File In Section: Product Recalls  
Bulletin No.: 09041A  
Date: June 2009

# Recall Bulletin

**SUBJECT:** Shift Lever Indicator May Not Display Correct Gear

**MODELS:** 2009 Buick Enclave  
2009 Chevrolet Cobalt, HHR, Malibu, Traverse  
2009 GMC Acadia  
2009 Pontiac G5, G6  
2009 Saturn AURA, OUTLOOK

2269489

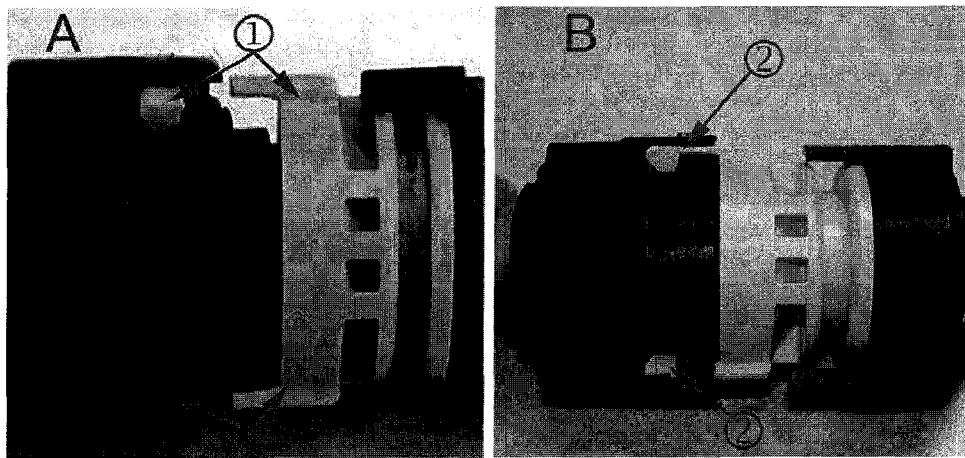
- (1) Shift Cable Locking Tabs
- (2) Shift Cable Adjuster Locking Clip

1. Open the hood and locate the transmission shift cable.
2. Determine if the transmission shift cable locking tabs are fractured and separated.

2269486

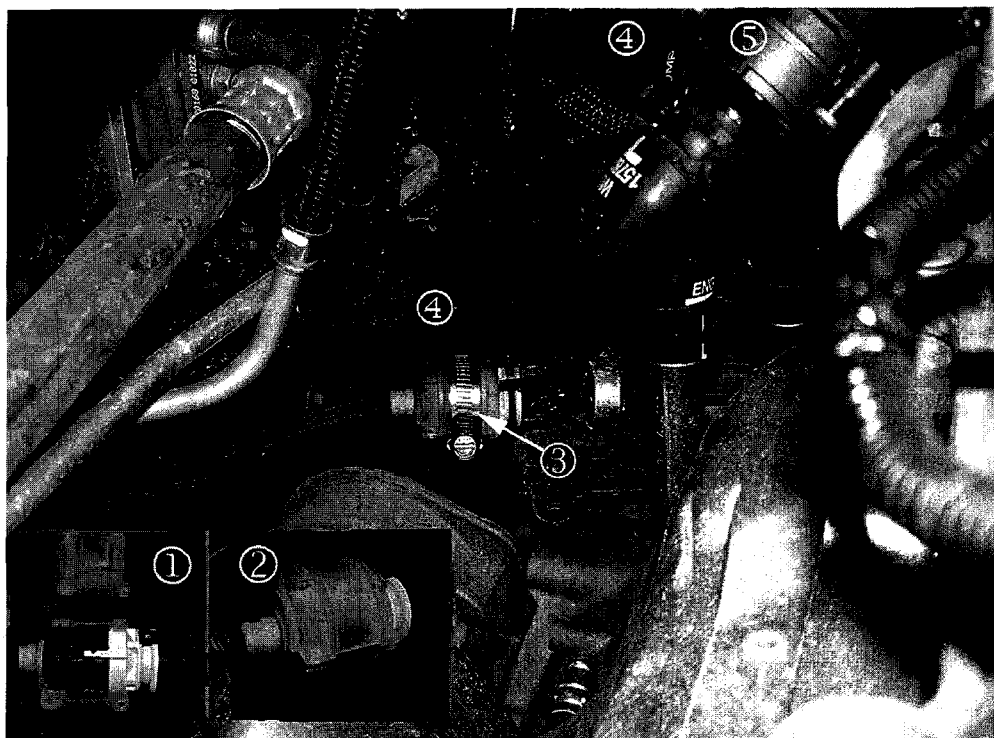
- If the transmission shift cable locking tabs (1) are fractured and separated (A), remove the transmission shift cable and replace it with a new one. Refer to *Floor Shift Control Cable Replacement* or *Range Selector Lever Cable Replacement* in SI. No further repairs are required after replacing the transmission shift cable. Submit warranty claim.
- If the transmission shift-cable locking tabs (2) are NOT fractured and separated (B), install the transmission shift cable kit. Proceed to Step 3.
